66309B-09

S E R V I C E N O T E

**66309B – Mobile Communication DC Source, Dual-Output
15V/3A,12V/1.5A. GPIB**

**Power-On Self test Errors, Auto reboot, Blank display. No output Communication errors.
No communication when using the GPIB Interface.**

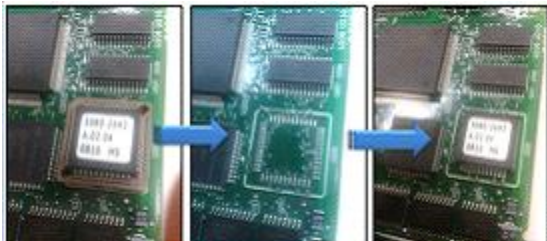
When the EEPROM is installed in the PLCC SOCKET (**Circuit Reference U205**) on the Interface board if there is not a gas tight connection between the EEPROM pins and the socket pins an intermittent connection will occur.

It has been determined when removing the socket and soldering the EEPROM (circuit reference U205) directly on the interface assembly “A2” would be very difficult (See Picture below), even having the correct tools, removal of the socket and replacement of the EEPROM is very difficult and may cause additional quality and reliability issues.

1. This problem can be solved by replacing the GPIB Interface assembly. See above for the tested interface P/N that is required to repair the instrument. The correct tested assembly for the specific model must be used when repairing a defective instrument.
2. This problem can also be solved by removing the socket (circuit reference U205) on the “A2” interface assembly and soldering the **Original** EEPROM directly to the Printed Circuit assembly.
